11/29/2022

Subject: Change to USCAR-12, Rev 6 (Revision Letter #6)

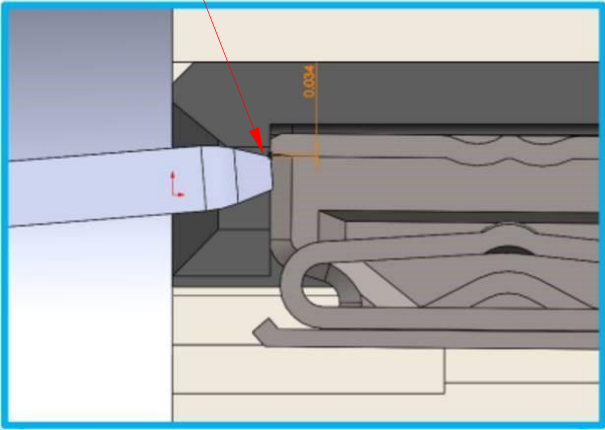
Female terminal lead-in design was not described in USCAR-12.

Section C23 has been added with the information shown.

#	REQUIREMENT	CRITERIA
C23	<p>Receptacle terminal must have a lead-in that assures alignment of the blade, even in its worst case position (including angles). Mating blade terminal will enter the inside of the receptacle terminal without contacting the top of the blade or interfering with the side of the receptacle terminal.</p> <div style="border: 1px solid red; padding: 5px; margin: 10px auto; width: fit-content;"> <p>Lead-in assures blade will engage correctly. Shown is the least allowable lead-in.</p> </div> 	<p>CAD study of worst case (largest cavity) must show no incorrect interference of blade to top or inside of receptacle terminal. Confirm that the lead-in is at least as effective as shown in the graphic.</p>
